OTHER CHANGE – OTH/2025/12

776 PACIFIC PARADE, CURRUMBIN
JOB – 2130201

RE: **RESPONSE TO ACTION NOTICE:**
'OTHER' CHANGE TO MCU/2022/588 – CHANGING FROM 4 X DWELLINGS TO 5 X DWELLINGS AND SHOP.
776 PACIFIC PARADE, CURRUMBIN.
LOT 1 ON SP348547.
COUNCIL REF.: OTH/2025/12.

Figure 1: Perspective plan extract – upper level balcony planting.

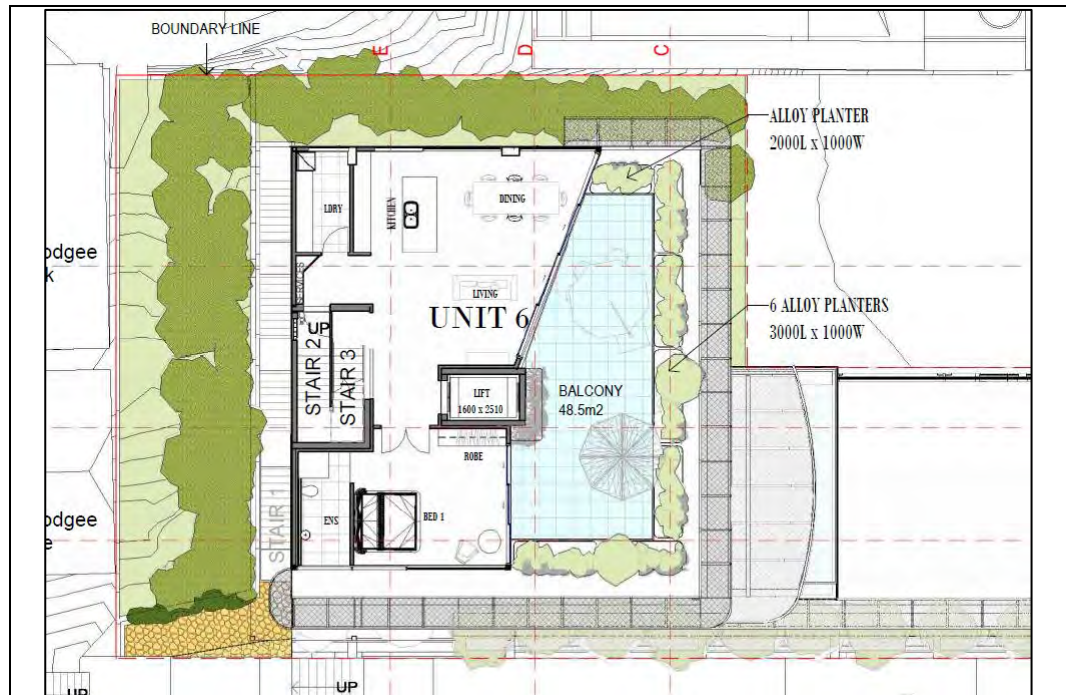
IMPACT ON THE CURRUMBIN HEADLAND
<p><i>Overall outcome (1) and (2) and PO3 and PO5 of the Ridges and significant hills protection overlay code. The developments changed design is now wider and higher than the approved outcome. Officers consider that this increase in bulk does not minimise the visual impact of the development within the Currumbin headland, resulting in a dominant outcome that is not compatible with the natural characteristics of the area. Further the development includes minimal landscaping treatments to soften this additional built form. As such, the applicant is requested to amend the design to be more sympathetic to the headland and meet Overall outcome (1) and (2) and PO3 and PO5 of the Ridges and significant hills protection overlay code.</i></p>

It is noted that this item has been discussed with Council having regard to the amended plans, (refer to Part 2 for both architectural and landscape plans). In terms of the above points raised by Council it is noted that the amended plans provide for landscaping on the northern side of the building as well as on the upper level balconies and to the rear of the building. Together these landscape spaces will soften the built form of the upper levels and provide a contribution to the landscape amenity of the headland.

It should also be noted that the proposed development provides extensive landscaping, more than found on other developments in the area. This includes landscaping to the balconies, the southern façade adjoining the walkway, the rear of the building, the northern side etc. On balance it is argued that the proposal will provide a significant improvement to landscape amenity in the locality.

SECTION
C-D

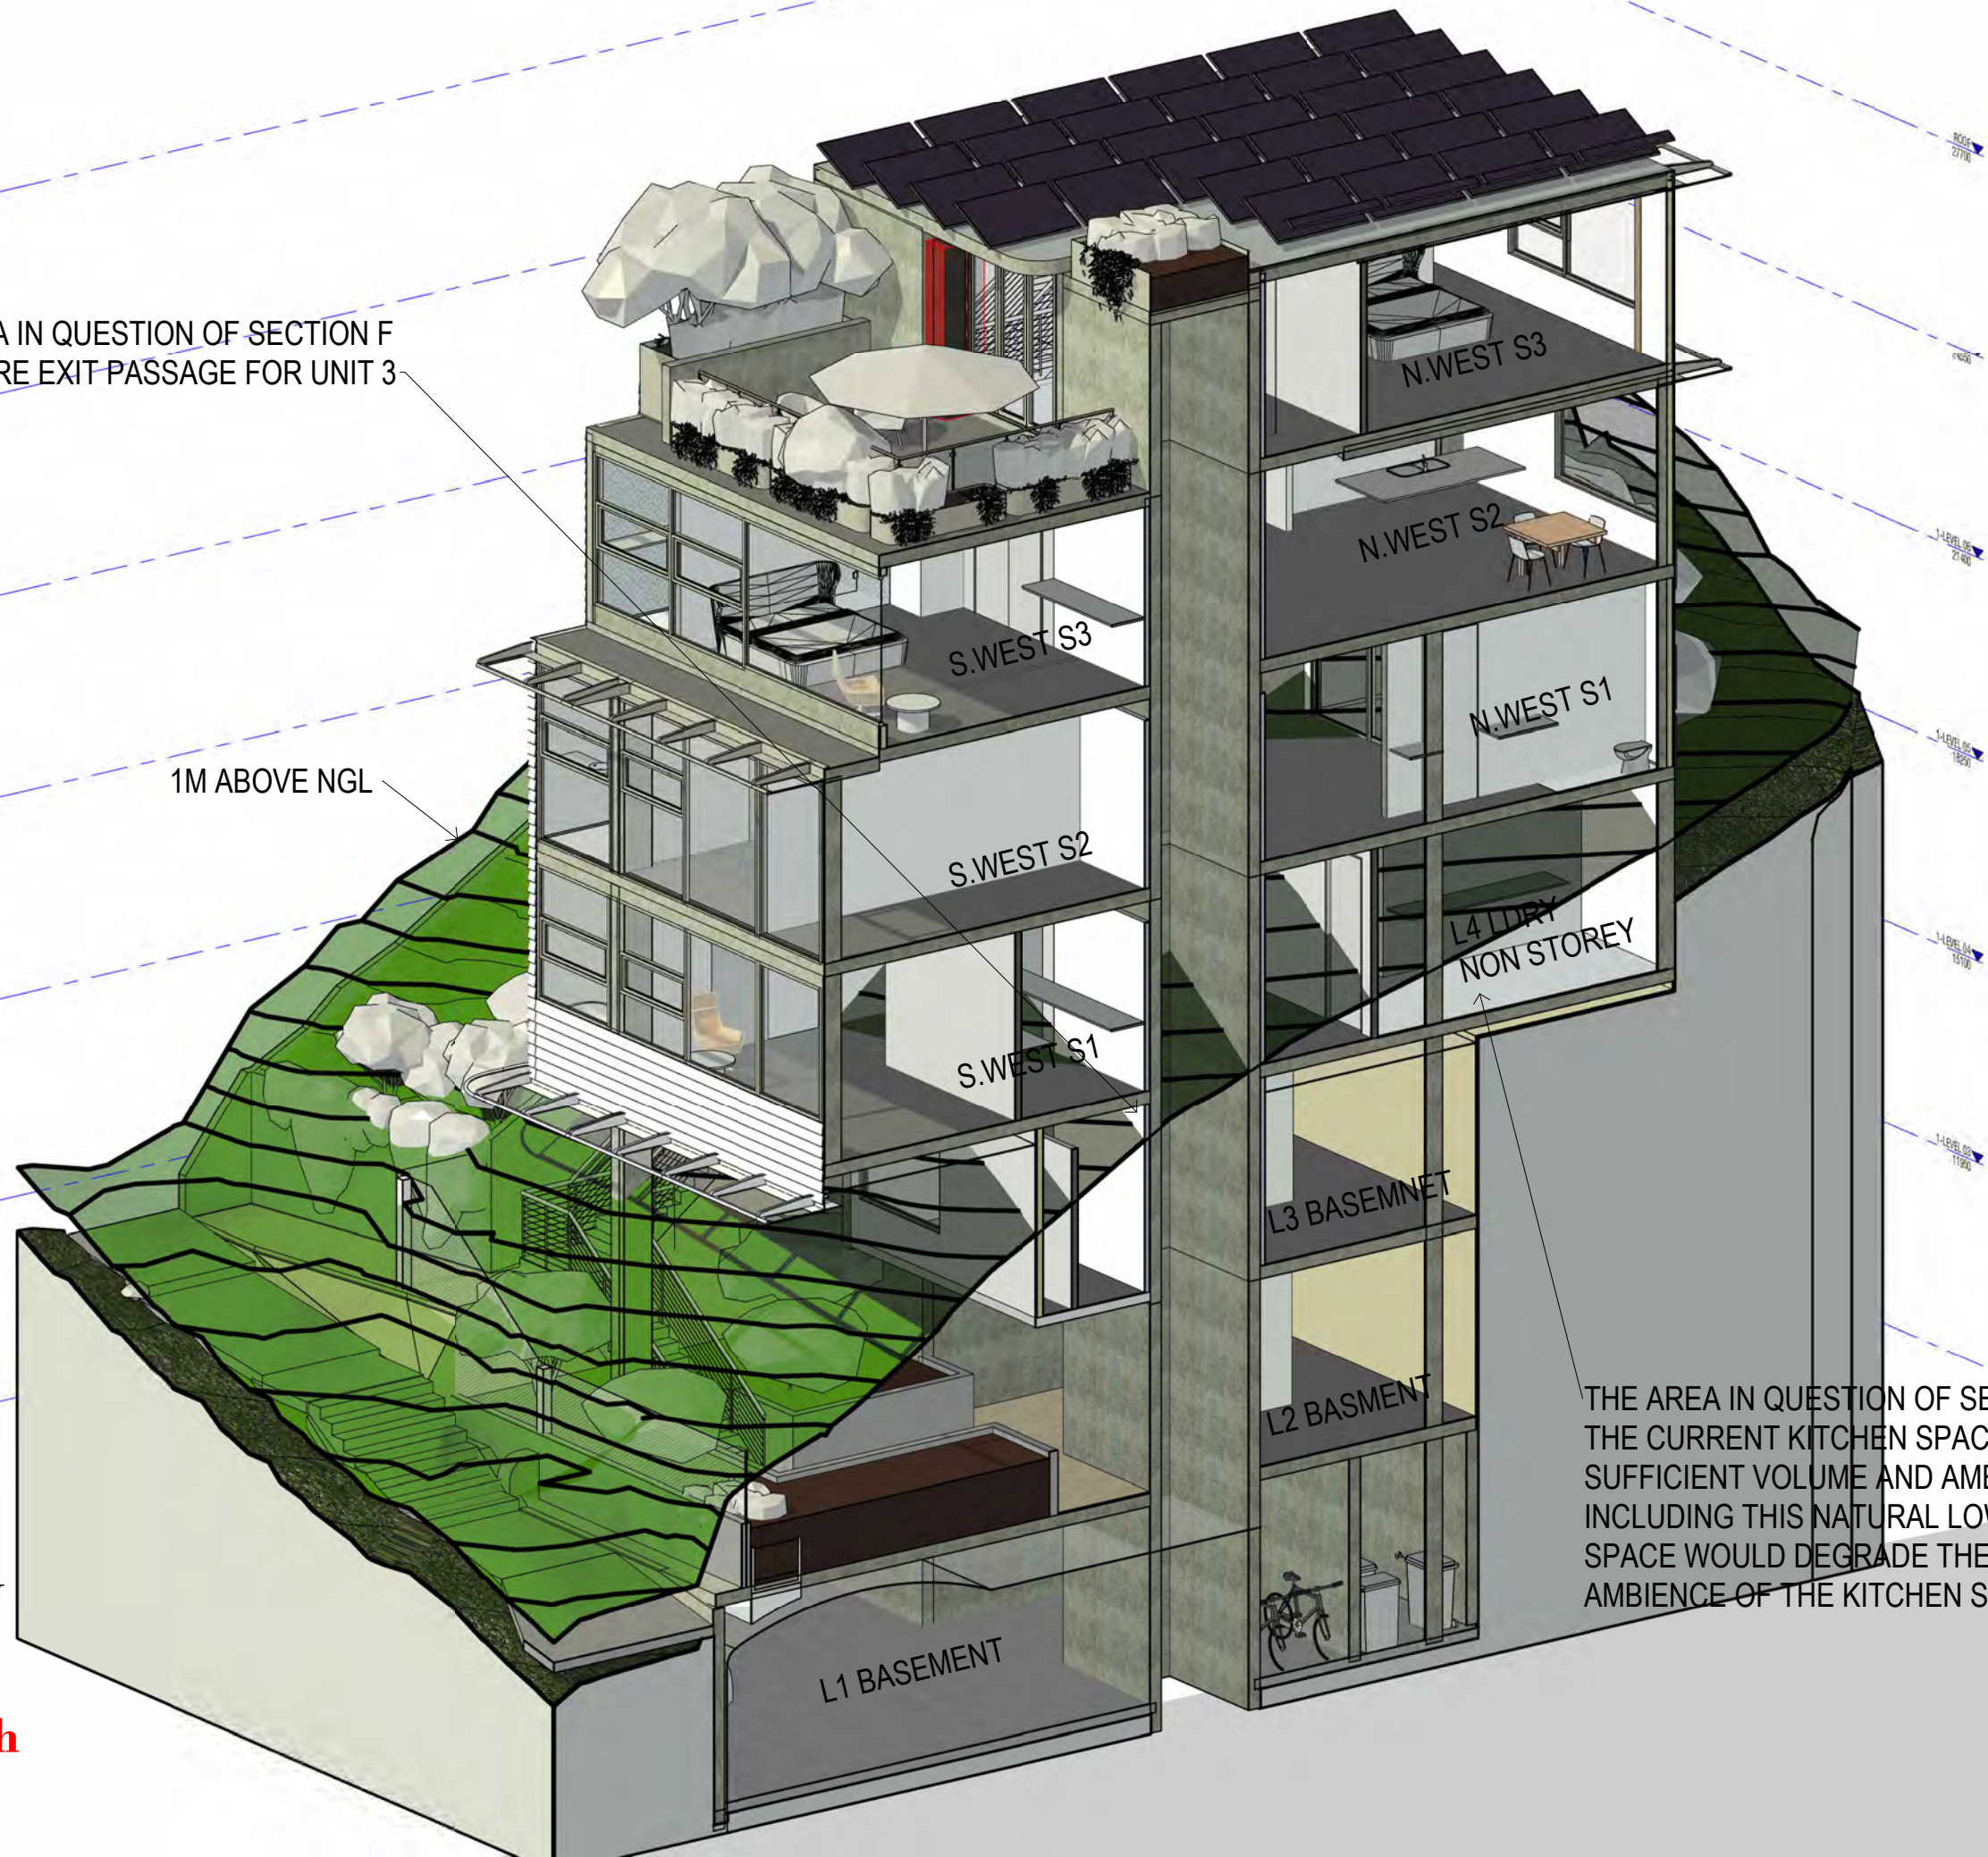
BUILDING HEIGHT
<p><i>The applicant has applied for a Code assessable application. However, City officers are not convinced that the application material sufficiently demonstrates the proposed development is no higher than 3 storeys / 15 metres. In this regard, City officers note the following:</i></p> <ul style="list-style-type: none">▪ <i>It appears that the new design includes more than 3 storeys within a vertical plan and above the natural ground level. It is noted the applicant contends some of these areas include a laundry, bathrooms etc that can be excluded from the storey definition. However, these rooms are not only contained within a space containing only a bathroom, shower room, laundry, toilet or other sanitary compartment, but include other rooms and areas within the space preventing these areas from being excluded.</i>▪ <i>The development includes a number of body corporate storage areas and other unmarked areas that either do not met the exclusions within the definition of a Storey (included for reference below) or have the capability of being utilised as a room or storage area not included within the exclusions list of the definition of a storey.</i> <p>Definition of a storeys – Schedule 1.2 of the City Plan: <i>A space within a building between two floor levels, or a floor level and a ceiling or roof:</i></p> <p>a) <i>other than:</i></p>

<p>APPLICANT RESPONSE</p> <p>Included in Part 2 is an amended set of proposal plans with minor changes to ensure the proposed building is no more than 3 storeys in a vertical plane. We have also provided 3D isometric views, both with and without the grid lines to assist in interpretation of the number of storeys in a vertical plane (refer to Part 1) noting that storey labels have been added to these drawings to illustrate compliance.</p> <p>We note that it is difficult to assess the number of storeys in a vertical plane due to the complexities of the site levels and the buildings relationship to natural ground etc. We do however confirm that the building does not exceed 3 storeys in a vertical plane and that it is well below the 15m height limit for the most part.</p>
<p>UPDATED GEOTECHNICAL REPORT</p> <p><i>The proposed changed development is materially different to the approved outcome and will now be located over an additional ~200m² of land. Despite this additional land forming part of the application and a new built form being proposed, a revised Geotechnical report has not been provided.</i></p> <p><i>As such, the applicant is required to provide an updated geotechnical report which accurately references the proposed changed development and the new land now forming part of the subject site. The updated report should include updated recommendation(s) confirming that the newly proposed development can achieve a 'Low' or better level of land slide hazard risk rating.</i></p> <p><i>Officers note that the updated geotechnical report must be from a Registered Professional Engineer of Queensland (RPEQ) specialising in geotechnical engineering addressing the following issues in accordance with SC6.10 City Plan policy - Geotechnical stability assessment guidelines:</i></p> <p>a) <i>The report should provide a site-specific landslide risk assessment for the proposed development. The risk assessment should be based on surface and subsurface geotechnical information of the site. The report should demonstrate that the risk of landslide adversely affecting the subject site, adjoining properties and the proposed development is 'Low' or better. If the report determines a 'Moderate' or worse risk rating, it should recommend appropriate and adequate risk mitigation measures to reduce the risk rating to 'Low' or better;</i></p> <p>b) <i>The report should include a certification from a Registered Professional Engineer of Queensland (RPEQ) specialising in geotechnical engineering confirming that the proposed development is appropriate for the sloping nature of the site, and that the risk of landslide adversely affecting the subject site, adjoining properties and the proposed development is 'Low' or better; and</i></p> <p>c) <i>The report should provide an impact assessment of the proposed basement excavation on landslide risk of the site and include appropriate engineering recommendations to mitigate the risk and also to ensure no adverse impact on the stability and integrity of the adjacent properties/structures as a result of the proposed basement excavation/construction.</i></p> <p><i>Although not a requirement, officers suggest that additional core samples be undertaken within the new land now forming part of the site. Furthermore, officers suggest that when finalising their recommendations that the geotechnical engineer considers the land slips that occurred through recent construction of the Currumbin Junior Surf Lifesaving as learnings and considerations maybe be applicable to the subject site.</i></p>

THIS VERTICAL PLANE IS IN LINE WITH
THE SOUTH EAST FACE OF LEVEL 6
WHICH IS 800MM SOUTH OF GRID D

THIS AREA IN QUESTION ONLY APPEARS TO BE
OVERHANGING THE SOUTH EAST 3 STOREYS
DUE TO IT BEING SETBACK FURTHER FROM THE
SOUTH BOUNDARY

THIS SECTION OF THE CARPARK IS A STOREY
